# HISTORIC AND DESIGN REVIEW COMMISSION

October 05, 2022

**HDRC CASE NO:** 2022-470  
**ADDRESS:** 521 E DEWEY PLACE  
**LEGAL DESCRIPTION:** NCB 2964 BLK 3 LOT E 24 FT OF 5 & W 36 FT OF 6  
**ZONING:** MF-33, H  
**CITY COUNCIL DIST.:** 1  
**DISTRICT:** Tobin Hill Historic District  
**APPLICANT:** America Santiago/Santiago Construction  
**OWNER:** CARDENAS ALEJANDRO JR  
**TYPE OF WORK:** Window replacement  
**APPLICATION RECEIVED:** September 01, 2022  
**60-DAY REVIEW:** Not applicable due to City Council Emergency Orders  
**CASE MANAGER:** Claudia Espinosa  
**REQUEST:**

The applicant is requesting a Certificate of Appropriateness for approval to replace forty-four existing windows with aluminum windows. The existing windows consist of original wood windows as well as non-original aluminum and vinyl windows.

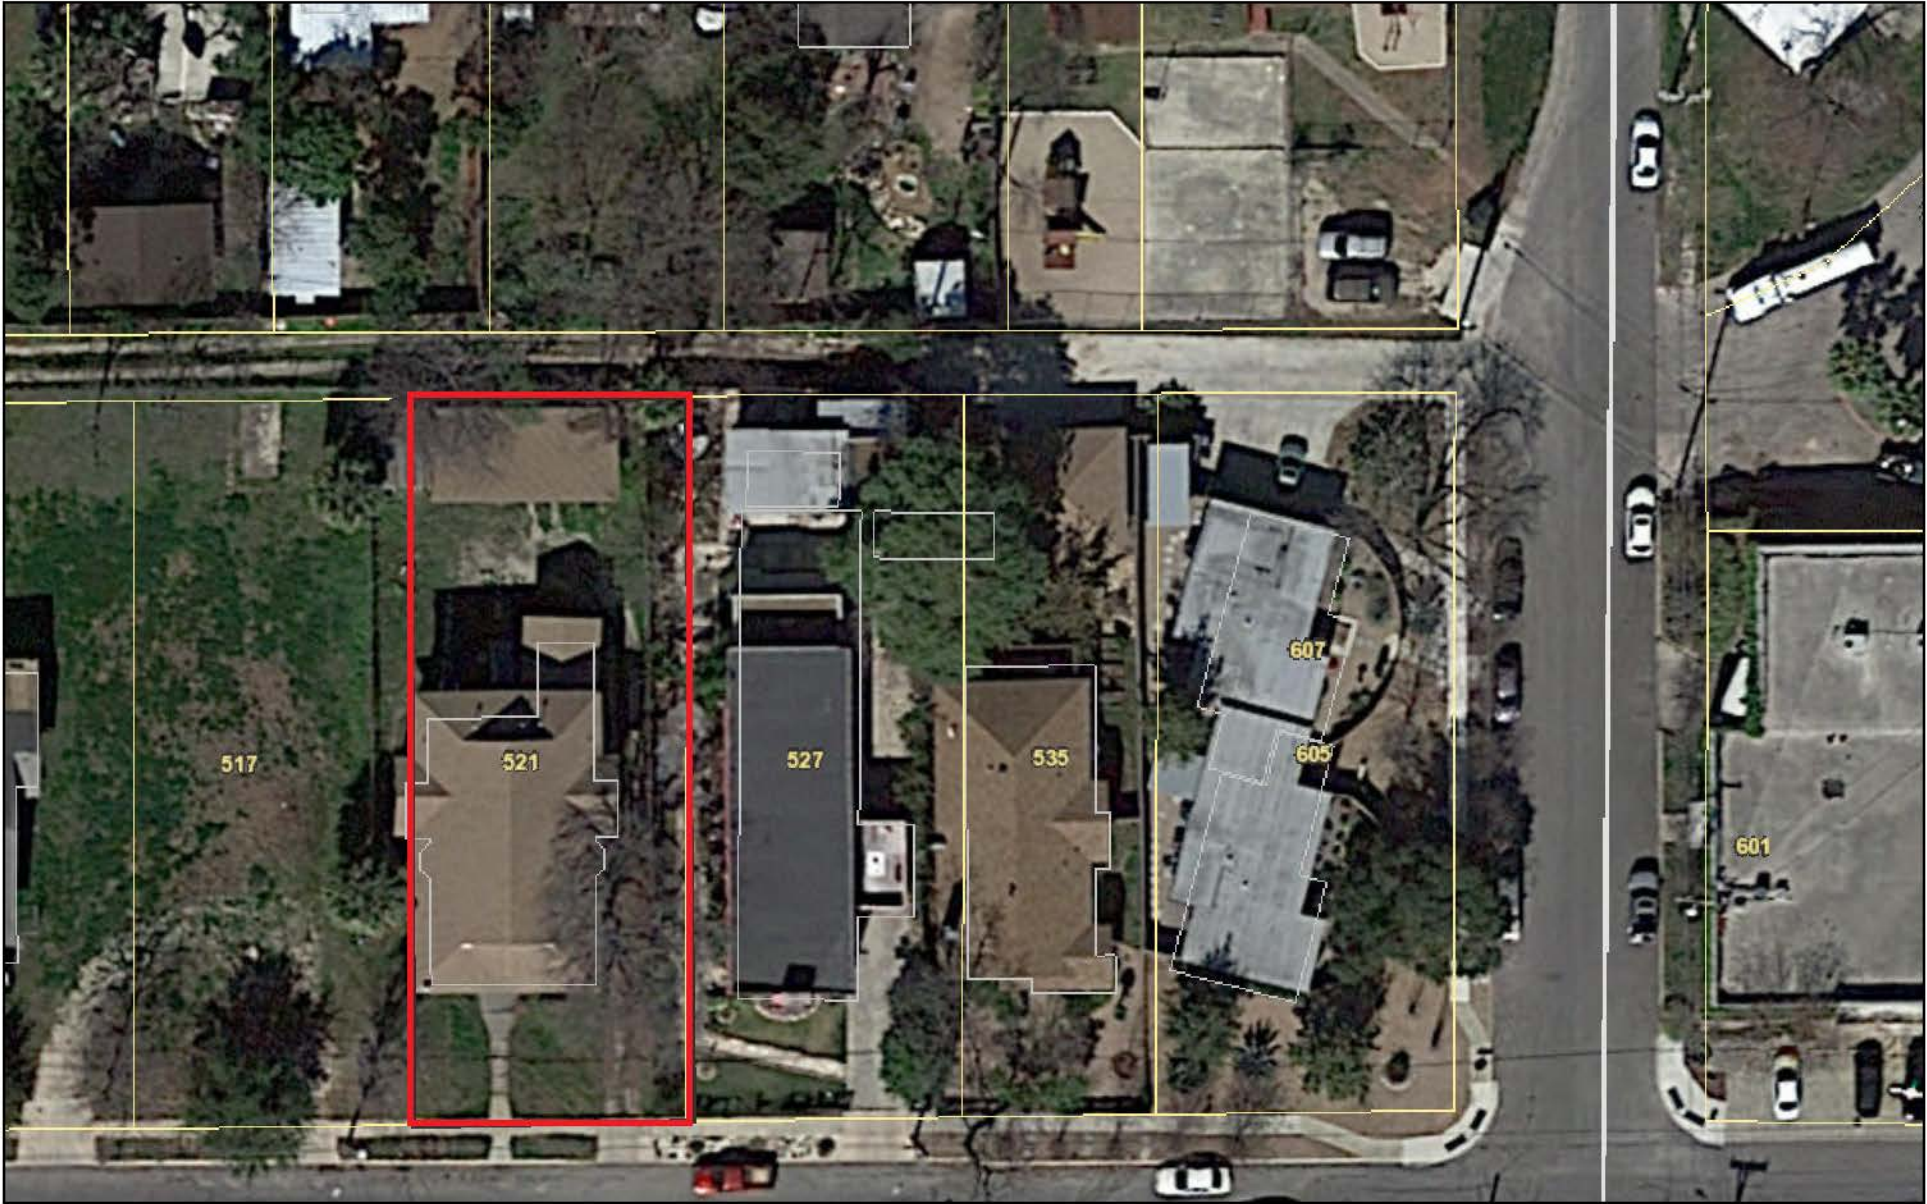
- a. The structure located at 521 E Dewey Pl was constructed circa 1921. The two-story, multi-family residential structure features a primary, turned gable roof with a double front porch, wood siding, and sashed wood windows with a combination of replacement windows that feature aluminum and vinyl materials. The primary structure first appears on the 1922 Sanborn map is contributing to the Tobin Hill Historic District.

- b. SCOPE OF WORK – At this time, the applicant is requesting a Certificate of Appropriateness to replace forty-four (44) windows. Existing windows onsite are original one-over-one wood, and non-original aluminum and vinyl windows. Staff has been unsuccessful in scheduling a site visit with the property owner to inspect the existing windows.

- c. WINDOW REPLACEMENT: EXISTING CONDITION – Per the submitted application documents, OHP staff does not find the original wood windows to be in a state that is beyond repair. Staff has observed evidence of paint flaking, and deteriorated glazing. However, almost all of the original wood is intact in all cases with very limited evidence of irreversible rot or damage. The joints of the top sashes appear to be in good condition with no evidence of slipping or separation. Staff finds that all windows are in repairable condition, with most requiring minimal repair and intervention like re-glazing and painting, along with refitting into the trim and frames. Staff finds that the existing wood windows should be repaired, in-kind. Aluminum and vinyl windows may be replaced with a window that is consistent with staff's standards for replacement windows. The replacement of aluminum windows that are consistent with staff's standards for replacement windows would be eligible for administrative approval.

Staff recommends the applicant repair the existing, wood windows with in-kind materials. Staff does not recommend the replacement of any wood windows.

Aluminum and vinyl windows may be replaced with a window that is consistent with staff's standards for replacement windows. The replacement of aluminum windows that are consistent with staff's standards for replacement windows would be eligible for administrative approval. Staff's standards for replacement windows are noted in the applicable citations.
